SUMMARIZATION OF NEW APPENDICES (B, C, D, E, F, G, H)

REVISION: C (supersedes Rev B, dated June 2, 2026)

RE: Supplemental Public Comments and Risk Assessment regarding the Proposed 20 MGD Wastewater Treatment Facility

LOCATIONS UNDER CONSIDERATION: Sites 1 through 7 — Mann Road, Berea Church Road, and Coles Ferry Pike corridor, Lebanon, TN

Exhibit C-1: 0.5-mile, 1.0-mile, and 2.0-mile rings centered on 3230 Mann Road, plotted on the TDEC Water Wells Desktop Application map. Each dark dot represents a permitted private water well in the TDEC database.

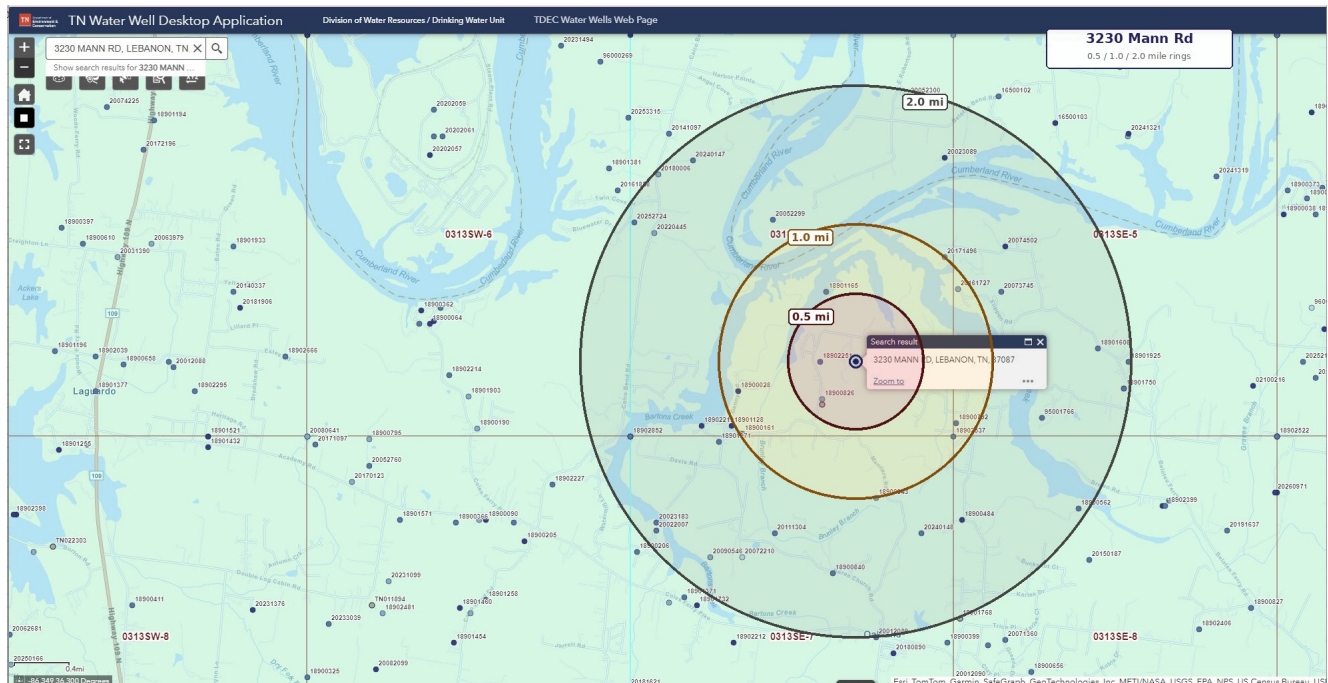
A query of the Tennessee Department of Environment and Conservation (TDEC) Water Well Locations public database identifies **a minimum of 38 permitted private wells within the 2-mile contamination radius** surrounding the proposed Mann Road and Berea Church Road footprint. Of these:

- **6 wells are located within 0.5 miles** of a proposed site, including a well at 1079 Berea Church Road (Coster) situated approximately 850 feet (0.16 mi) from the Mann Road site;
- **16 wells are located within 1.0 mile** of a proposed site;
- **38 wells are located within 2.0 miles** of a proposed site, the outer boundary of the karst contamination radius identified in Section VI.

The geographic distribution of these wells, with concentric 0.5-mile, 1.0-mile, and 2.0-mile rings, is depicted in Exhibit C-1 below. Recorded uses include residential drinking water (32 wells), agricultural and irrigation (9 wells), and geothermal heat pump (3 wells). The Site Selection Committee has not, to the petitioners' knowledge, entered these figures into the public record.

Important caveat: The figure of 38 wells is a minimum. The TDEC Water Well Locations database includes only those wells for which a licensed driller filed a report. Wells drilled prior to the

- Formally request a hydrogeological study from a qualified third party documenting (or refuting) hydraulic connectivity between the proposed site footprint and the LUD well field;
- Require coordination with the LaGuardo Utility District Board of Commissioners as a prerequisite to any further consideration of the Mann Road and Berea Church Road addresses;
- Enter the well-count data and accompanying ring map (Exhibit C-1) into the official public record of the site selection proceedings, and supplement it with an independent staff verification against the most current TDEC Water Well Locations database;
- Provide written notification to each identified well owner, and to all LUD ratepayers, of the proposed siting and the karst-aquifer contamination pathway described in Section VI of the principal statement.
